Request for Additional Information No. 47 (829, 842, 880), Revision 0

U. S. EPR Standard Design Certification

AREVA NP Inc.

SRP Section: 18 - Human Factors Engineering

Figure 18-28-1—HED Resolution Process

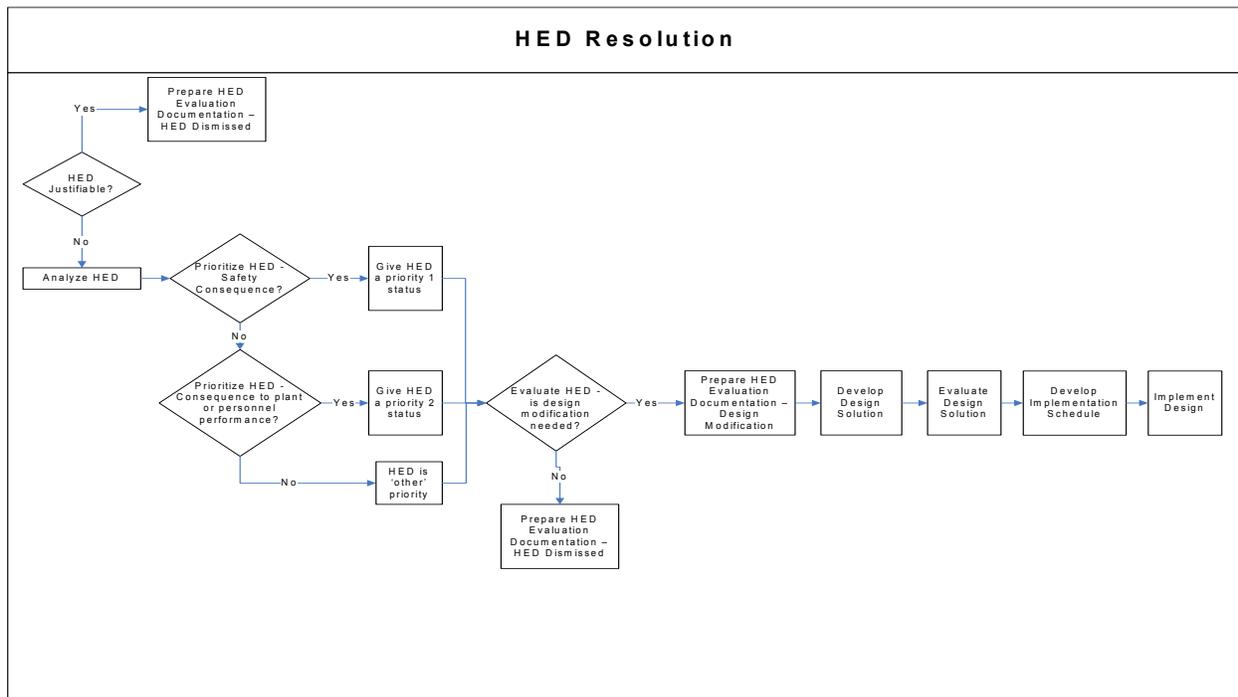
Please explain how and when the the additional detail in NUREG-0711 section 11.4.4.2 will be addressed.

The Human Engineering Deficiency (HED) resolution procedure can be found in the U.S. EPR verification and validation (V&V) implementation plan. The HED resolution process, outlined by Figure 18-28-1—HED Resolution Process, includes HED Justification, HED Analysis, HED prioritization, HED Evaluation Documentation, Development of Design Solution, and Design Solution Evaluation. The HED resolution procedure is utilized for the V&V of the human factors engineering (HFE) program.

The detailed steps as described in NUREG-0711 for HED review criteria can be found in the U.S. EPR V&V implementation plan. The U.S. EPR V&V implementation plan has been developed and is available for inspection at AREVA NP offices. Additional details regarding human engineering discrepancy evaluations for the U.S. EPR are provided in this document.
